### HISTORIC PRESERVATION BOARD City Commission Chambers April 27, 2023 8:30 A.M.

### DESIGN REVIEW COMMITTEE

April 27, 2023

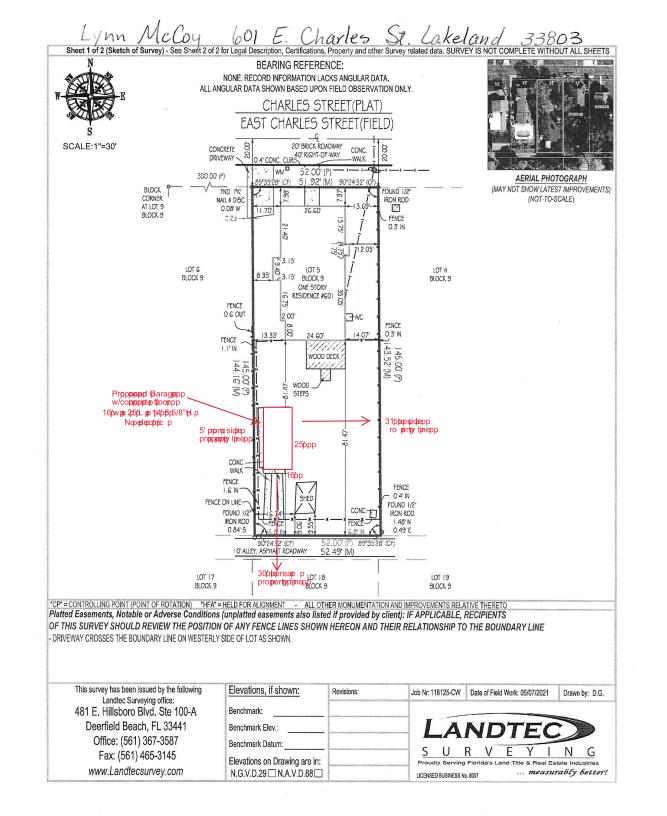
In evaluating the request with the Standards, staff finds that the proposed detached garage does not disturb the spatial relationships of the principal house, and its setting and integrity is maintained. New but similar materials will be used on the garage, which will be complementary in nature to the design of the house.

In evaluating the request with the Design Guidelines, staff finds the materials of the proposed detached garage are consistent with the Design Guidelines. Staff finds the style of the garage to be simple and compatible in design and subordinate to the subject house, as well as placed appropriately at the rear of the subject property. Finally, the setbacks of the detached garage meet the requirements of the Land Development Code for accessory structures.

Final Approval of the request as submitted.

Figure 1 Figure 2

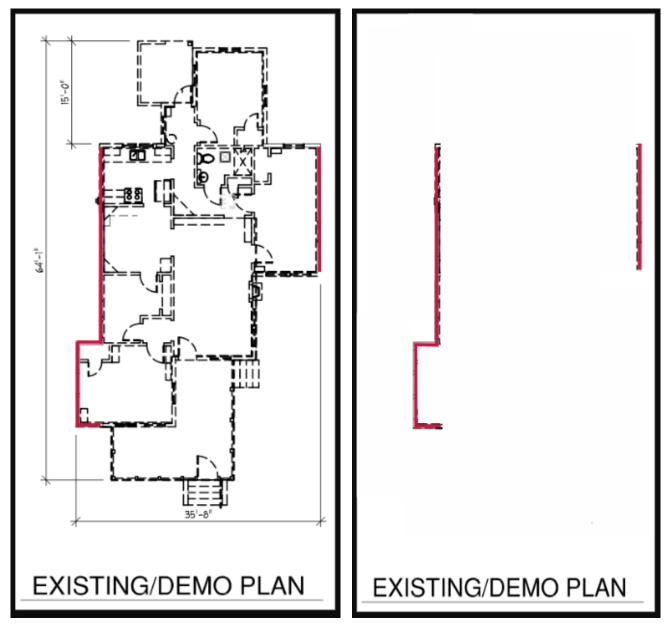
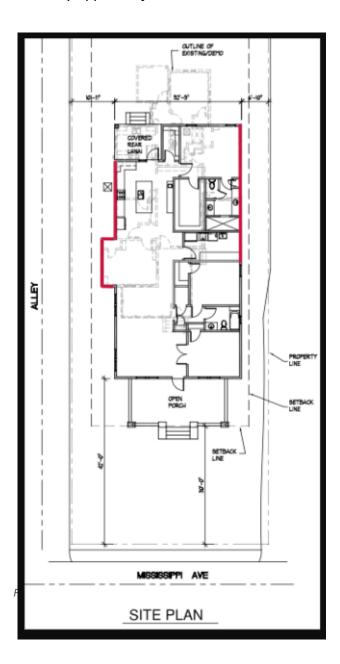
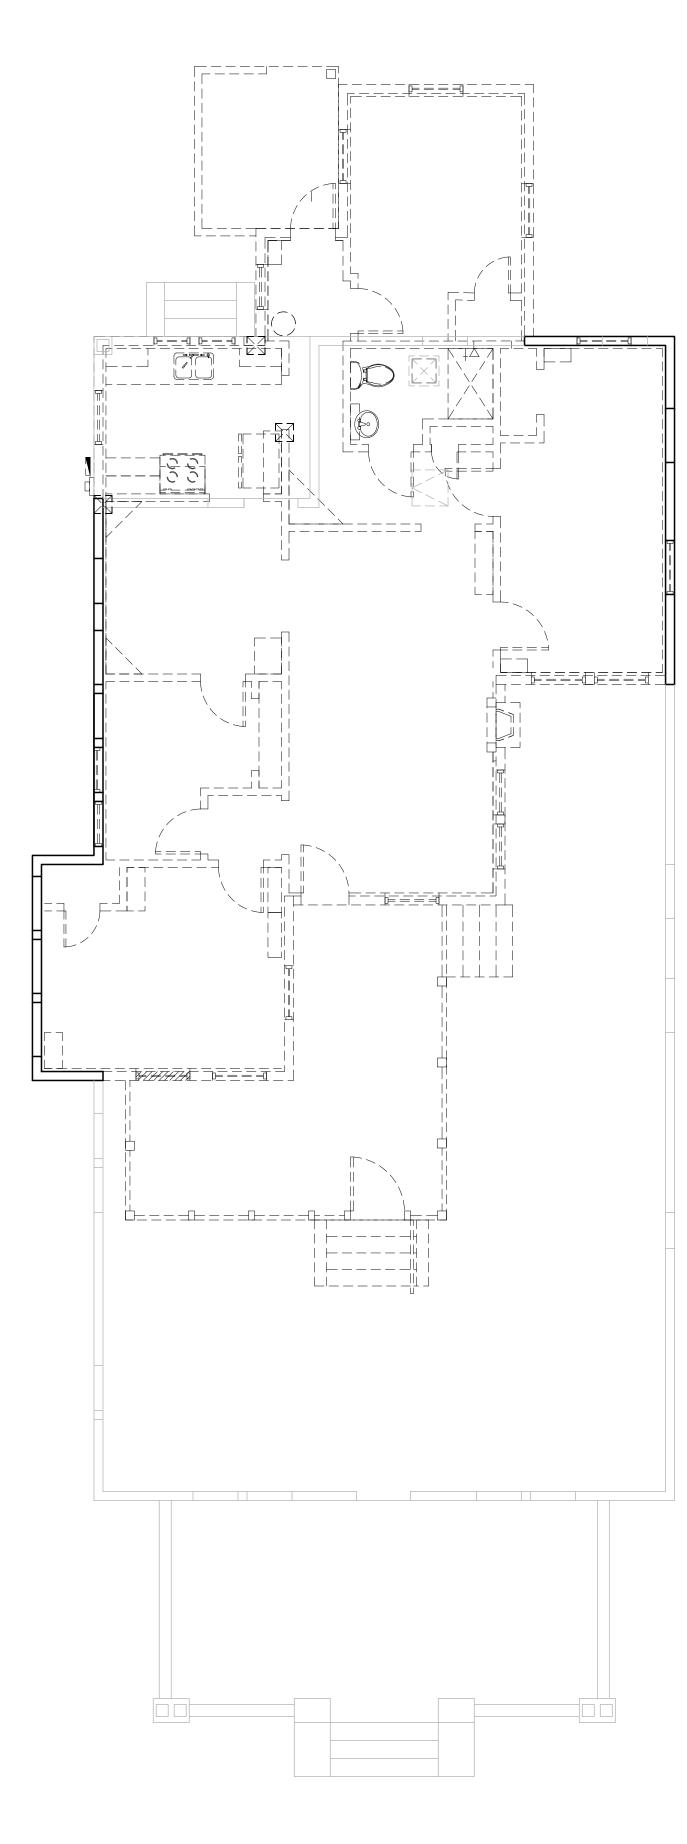
- The condition of the house, which has water and termite damage, wood rot, and foundation pier
  deterioration, makes the reuse of existing walls difficult. This was especially concerning to Building
  Inspection, which questioned whether it would be feasible to marry the old wall sections and foundation,
  with the new. In fact, the south wall is literally resting in the dirt.
- The complexity of a partial demolition versus a full demolition will result in additional time, risk, and cost, with only minimal value to the project in keeping a small portion of the structure's historic fabric.

- The walls that were originally planned to remain make up only a small portion of the entire structure. All
  other exterior walls, interior walls, flooring, windows, foundation, plumbing, electrical, mechanical and
  the entire roof structure have already been approved to be replaced.
- The Applicants are committed to maintaining the architectural style and character of this house through the previously approved design.

Figure 1 was submitted and approved during the December 2022 Historic Board meeting. For clearer visibility, we added red lines, depicting the North and South side wall portions that are in question. Figure 2 is the same drawing, with a depiction of only the remaining walls, not currently approved for removal.

Figure 3 was also submitted and approved during the December 2022 Historic Board meeting. For clearer visibility, we also added red lines, depicting the North and South side walls, not currently approved for removal.

- 1. New siding must match the exposure dimension of the original siding. All trim and casing should be similar to that of the historic structure and include corner boards and frieze boards.
- 2. Windows must be recessed to provide a shadow line and not installed flush to the exterior wall surface. Windows also must include historically appropriate trim, including header, sill, and apron.
- 3. Ensure that the front porch columns are properly aligned with the entablature beam, and that a frieze board of appropriate width covers the entablature beam.
- 4. Front door must feature full-lite, half-lite, or quarter-lite glazing.
